ROCKY REACH BIOLOGICAL OBJECTIVES 2013 STATUS REPORT

Second Draft

**ROCKY REACH HYDROELECTRIC PROJECT
FERC Project No. 2145**

**Public Utility District No. 1 of Chelan County
Wenatchee, Washington**

Figure 5-1. Rocky Reach dam fishway half-duplex PIT tag antennas locations, RR01-RR07.

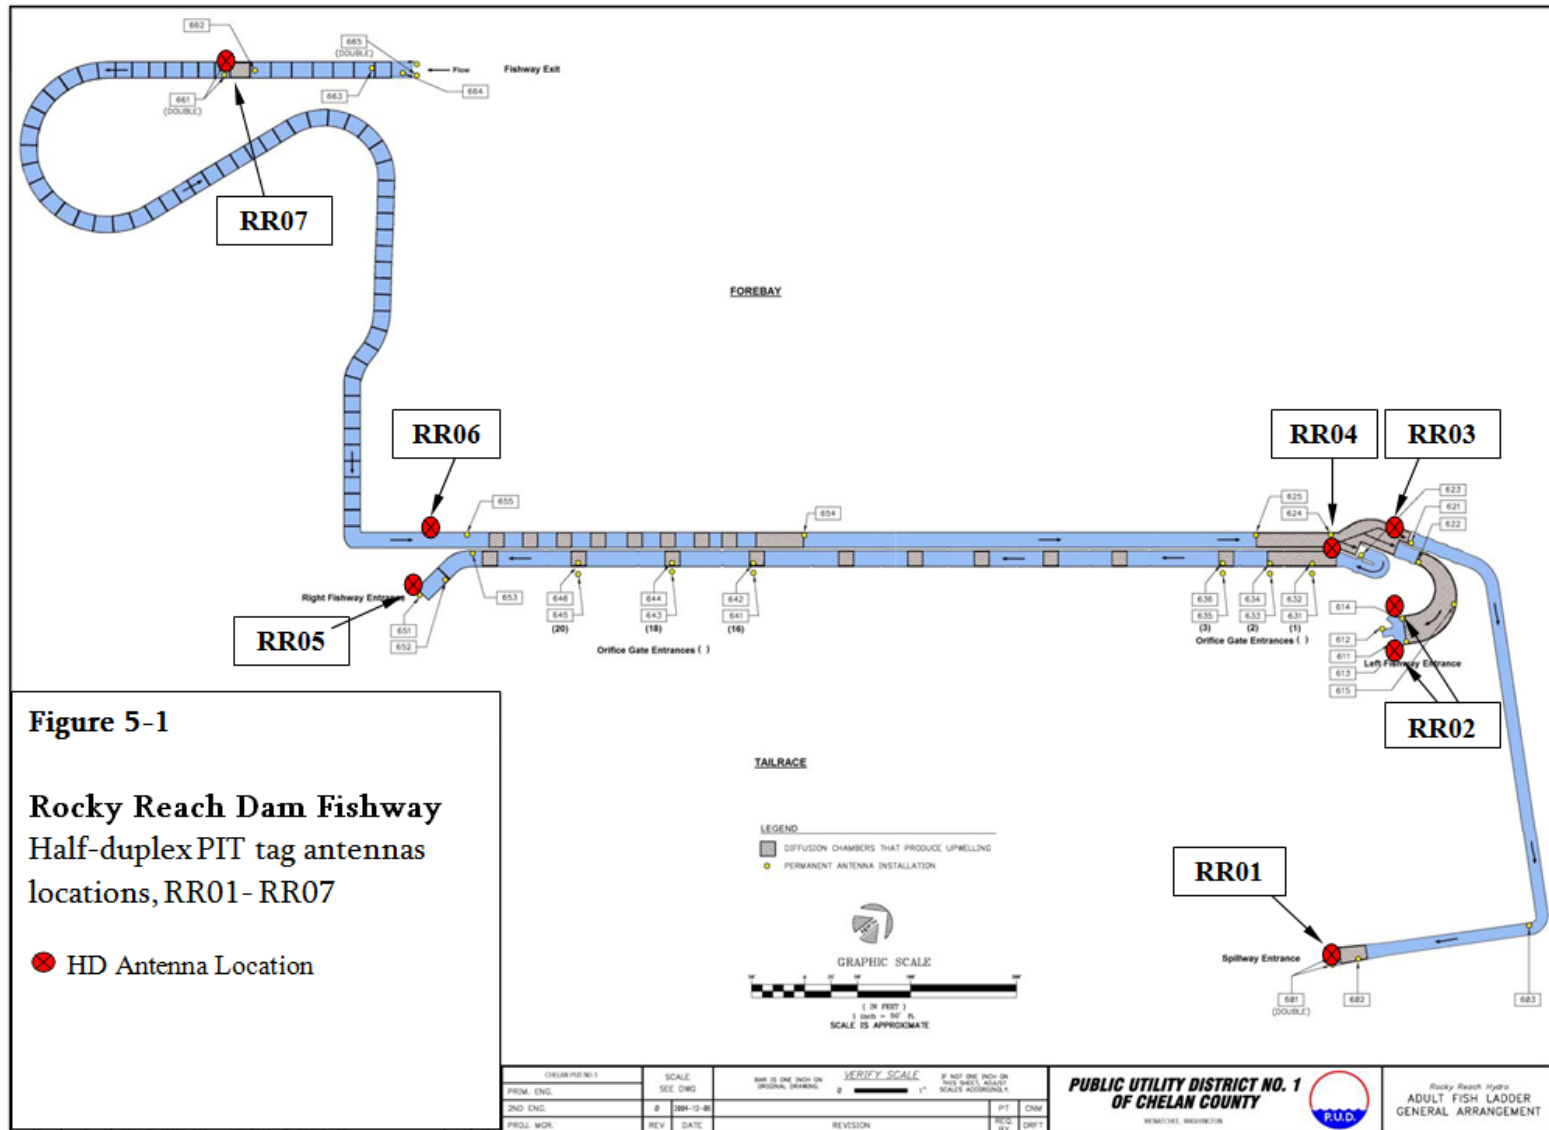
Commenting Agency	Agency Comment	Chelan PUD Response
YN 2/21/14 Draft Report comments	Section 5, Page 28. In general, a picture of the locations of the arrays would be very helpful in following this discussion.	Diagram of Rocky Reach fishway and installed HD PIT tag antennas locations has been prepared and included in the revised report.
YN 2/21/14 Draft Report comments	Section 5, Page 28. Tables 5-2 and 5-3 contain essentially the same information, but one with considerable more detail than the other. It would be informative if 5-1 were the same as 5-2.	Table 5-1 reports physical locations of antennas in the Rocky Reach fishway. Table 5-2 and 5-3 contain tag passage data from individual fish in 2012 and 2013. We are unsure how to make Table 5-1 appear like Table 5-2 because they contain vastly different data. Detailed detection times and detection locations for 2012 adult passage were added to Table 5-2, as we believe that is what your comment intended to say.
